2015-2019MY
Soul EV (PS EV)

SC267Z (Rev 1, 05/07/2024)

HIGH-VOLTAGE BATTERY PACK ASSEMBLY
REPLACEMENT (SC267Z)

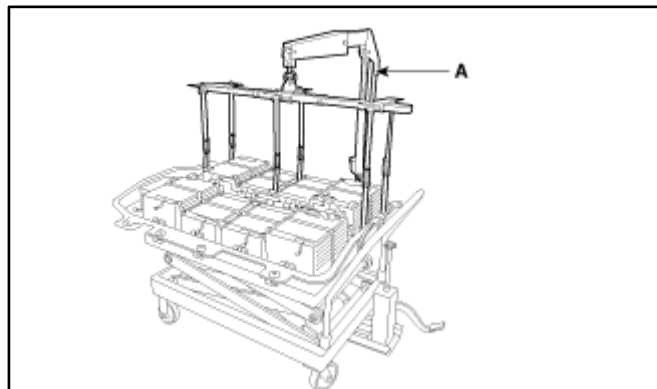
15-17MY ONLY new PN BPA is equipped with a "new" type harness. **(Rev 1) removed harness swap.**

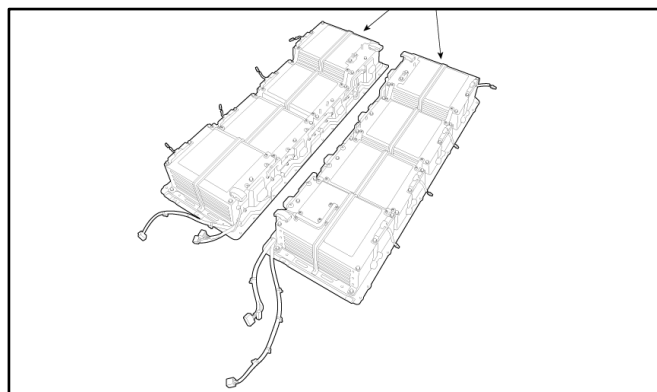
18-19MY ONLY new BPA is equipped with the "new" type harness. There is no need to swap.
